PUR-1306
ADDENDUM NO. 1
INVITATION TO BID

TAXIWAY "C" REHABILITATION AT
HAGERSTOWN REGIONAL AIRPORT

DATE: Wednesday, February 17, 2016

7 UNLIGHTED CLOSED RUNWAY MARKER
C5.05 NOT TO SCALE

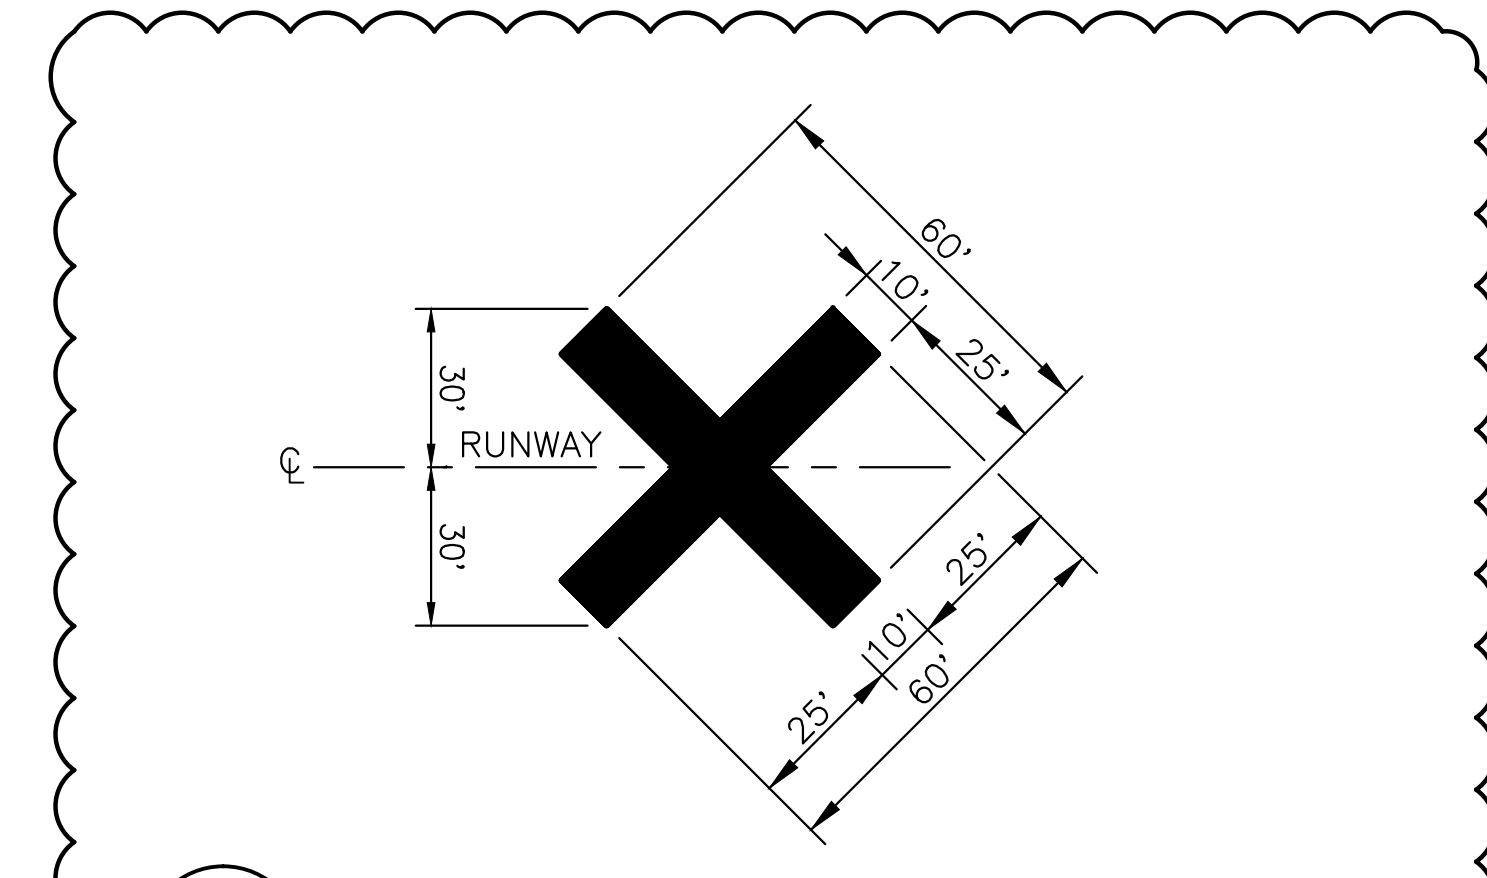
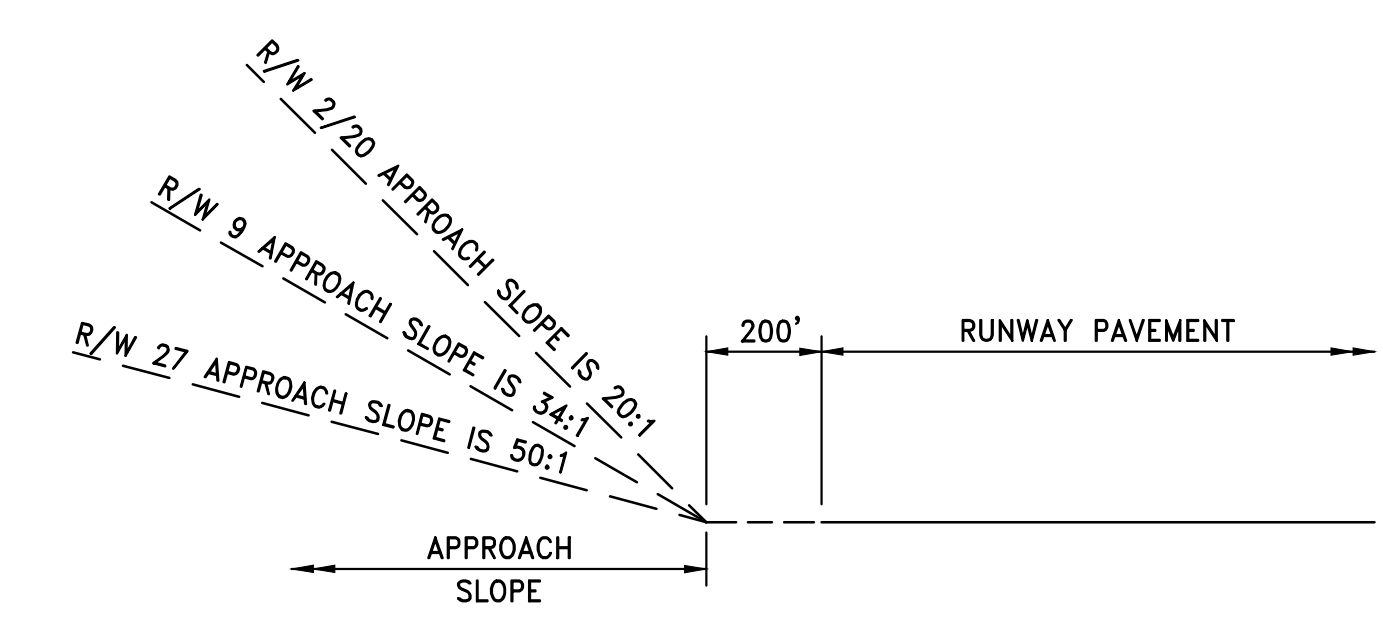
ITEM NO. 9: **Drawing Revision - Sheet C5.05 – Safety Phasing Notes and Details:**

Delete detail 7 and replace in its entirety. See reissued sheet.

- NOTES:**
1. TEMPORARY RUNWAY CLOSURE MARKERS SHALL BE AVIATION YELLOW WITH 6" BLACK BORDER.
 2. TEMPORARY UNLIGHTED RUNWAY CLOSURE MARKERS SHALL BE MANUFACTURED BY NEUBERT AERO CORP., CLEARWATER, FL. OR APPROVED EQUAL. (1-727-538-8744) INCLUDE COSTS PER SPECIFICATION SECTION 105.

SHEET No.:
E5.01

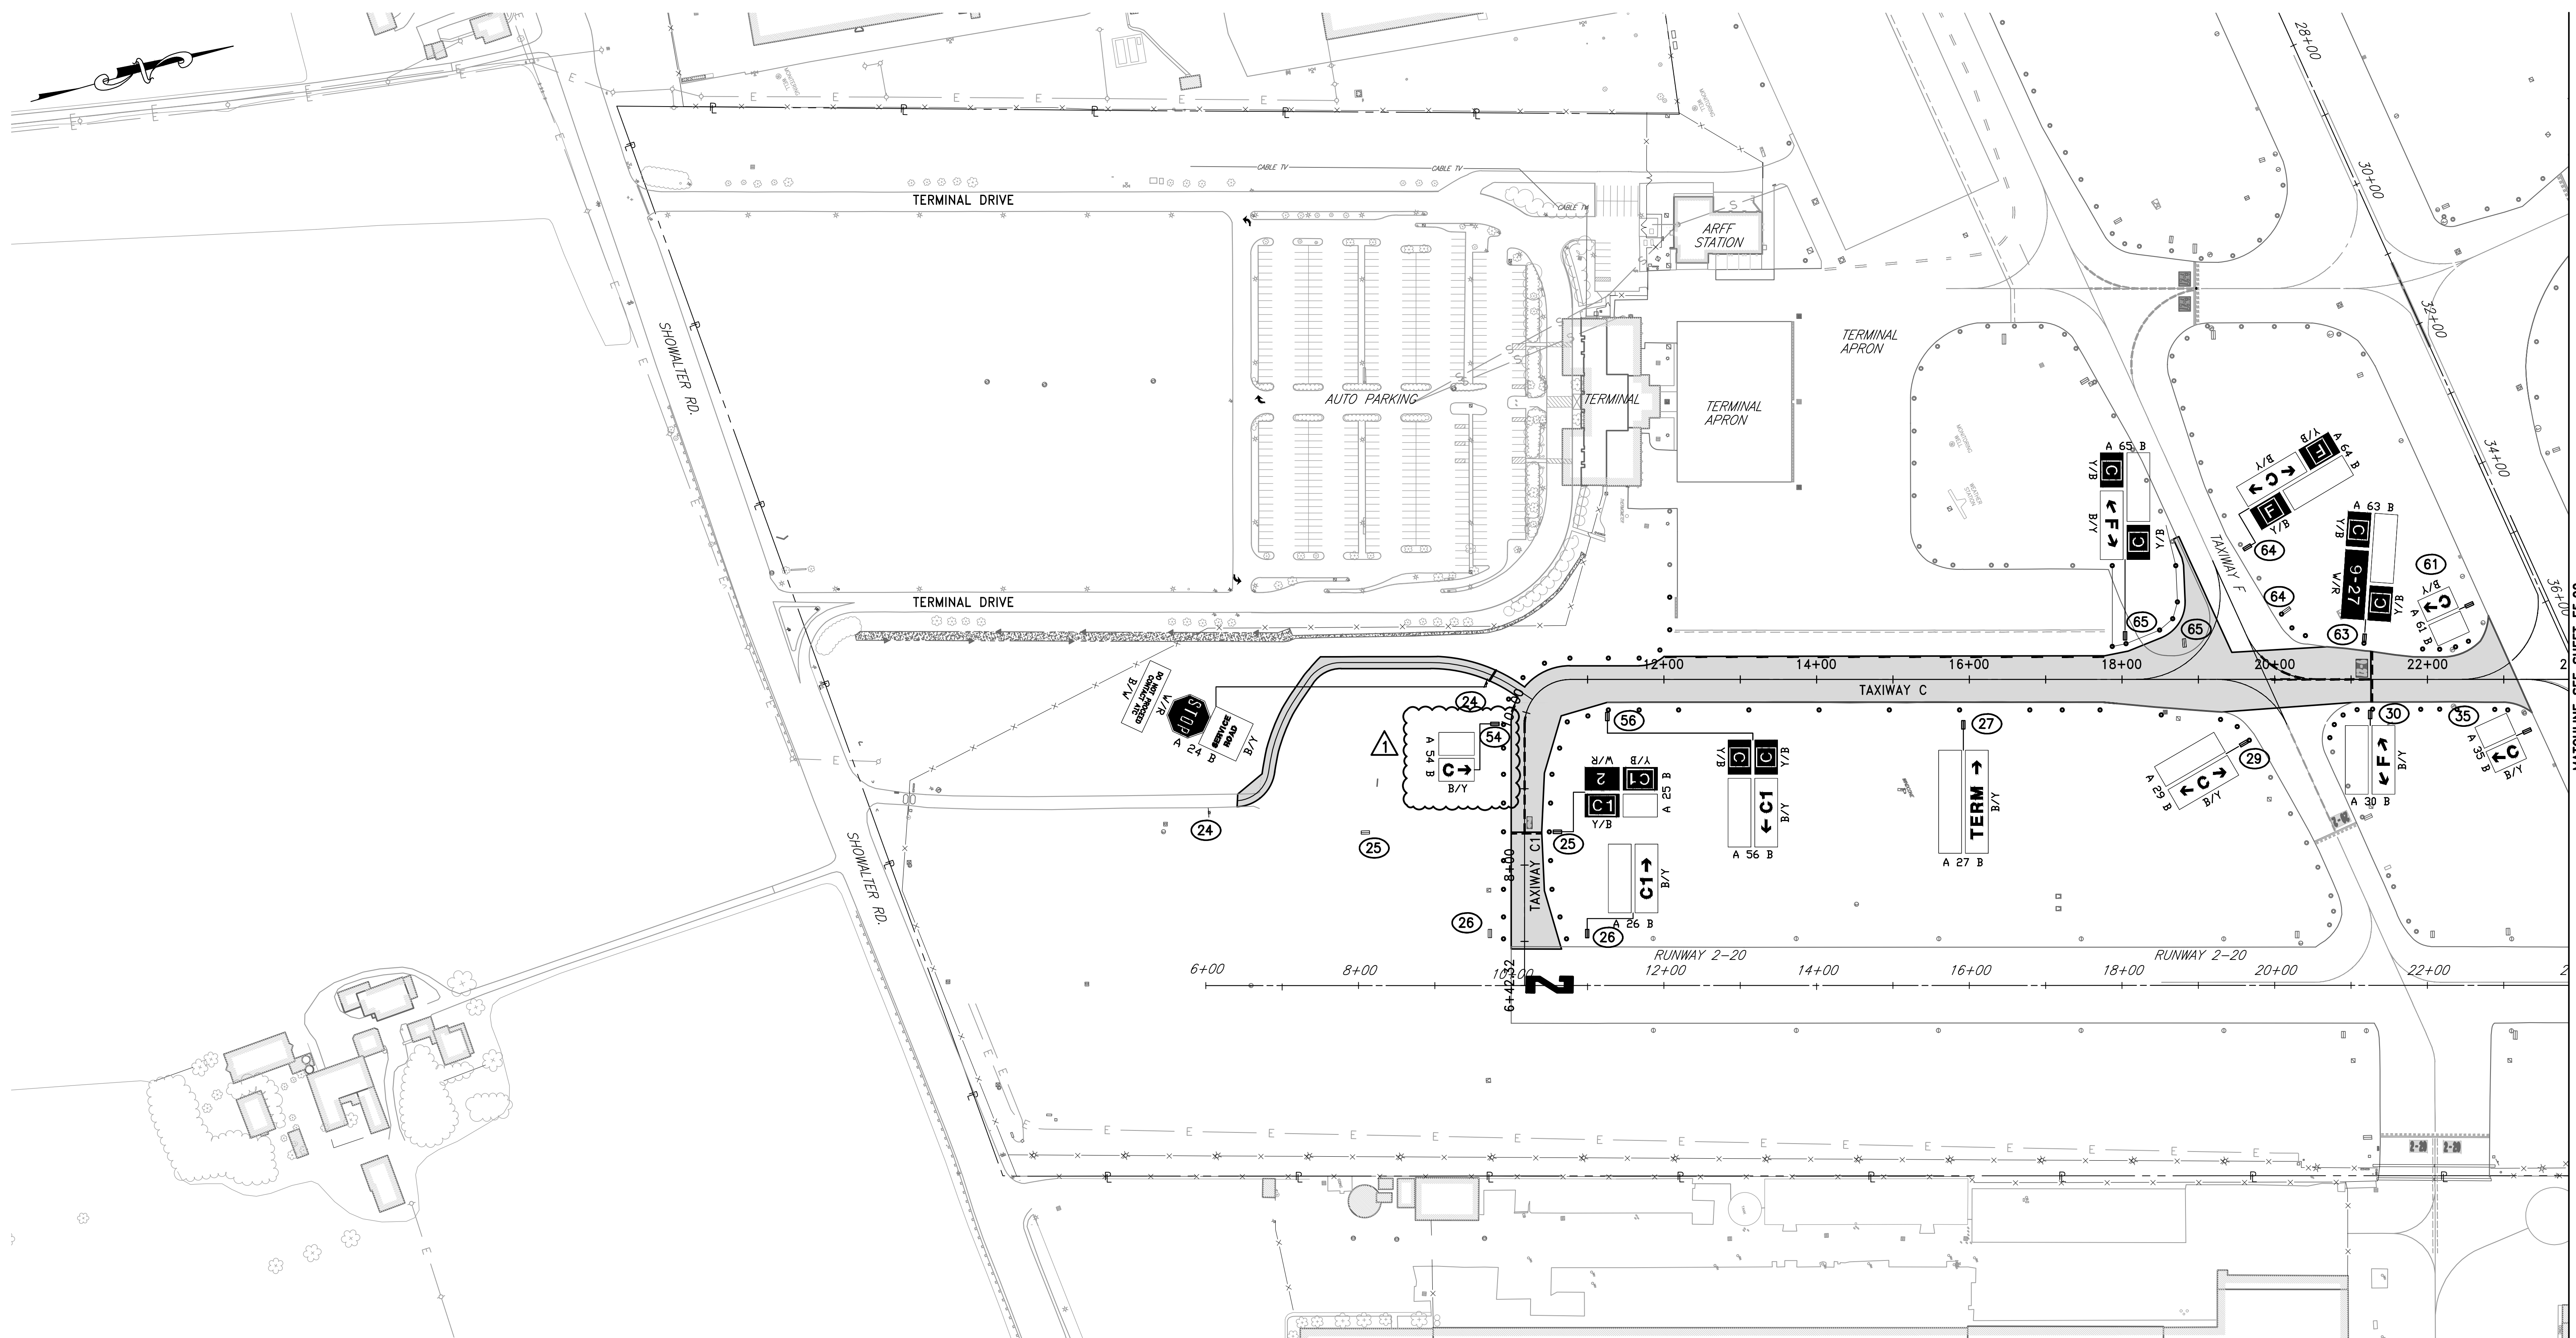
ITEM NO. 11: **Drawing Revision - Sheet E5.01 - Airfield Sign Plan 1:**

Add sign 54. See Reissued Sheet.

FAA AIP No.:	3-24-0019-051-2014
Bid No.:	PUR-1306
MAA Grant No.:	MAA-GR-15-009 (Design)
	MAA-GR-XX-XXX (Construction)
SHEET No.:	E5.03

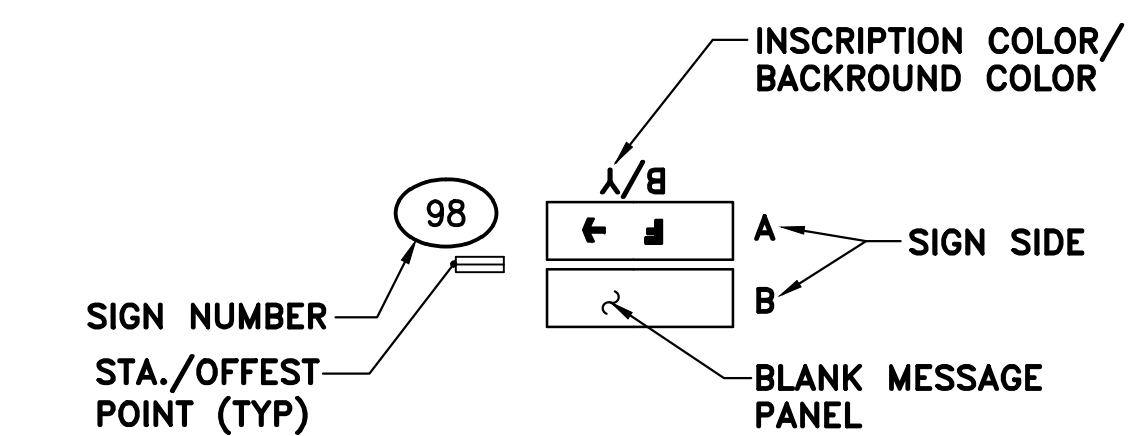
ITEM NO. 13: Drawing Revision - Sheet E5.03 –Airfield Signage Schedule:

Update signage legend/schedule. See Reissued Sheet
